Title: 2nd Response to OCC Highways Comments

Date: May 2022

- 1.1 Jubb has been commissioned by Hallam Land Management Ltd (HLM) to provide highways and transportation advice in relation to proposals for a residential-led mixed use development on Land north-east of the railway line in North West Bicester.
- 1.2 This technical note sets out, in table format, a response to Oxfordshire County Council's transport and highways comments relating to Jubb's Technical Note 02.

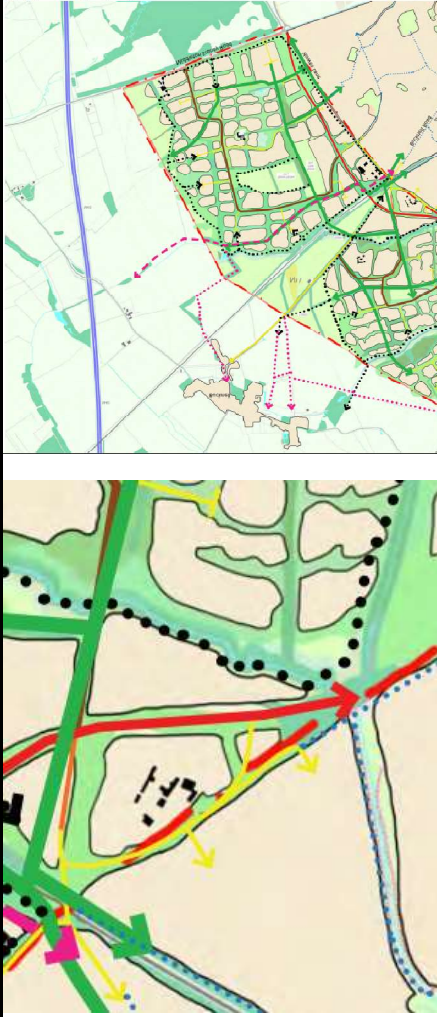
Fig 7.4	The secondary access onto Bucknell Road is too far south and therefore not in accordance with the Masterplan Strategy, which aimed	With a combination of highway design and traffic calming and traffic management measures along Bucknell Rd journey times to Bucknell	Please provide details of meetings and progress with discussions.	Public meeting held on 14.03.2022 where traffic calming proposals for Bucknell Road and Bucknell village were presented (see Appendix B). A

Document / Paragraph	OCC Comments to TA	Jubb Comments	OCC Comments to TN02	Jubb Comments
	<p>to discourage through traffic from using Bucknell Road by offering a much less direct route through the development.</p> <p>See comments below regarding design of junction. Off site highway works would be required at the southern end of Bucknell Road where it joins Lords Lane, in connection with the restriction to pedestrians and cyclists only. A TRO will be needed to close this section of Bucknell Road to traffic.</p>	<p>village will be increased, hence reducing the attractiveness of this route. Discussions are ongoing with Bucknell Parish Council regarding the exact nature of these measures.</p> <p>Noted and agreed.</p>		<p>response to the parish council's queries has been provided.</p>
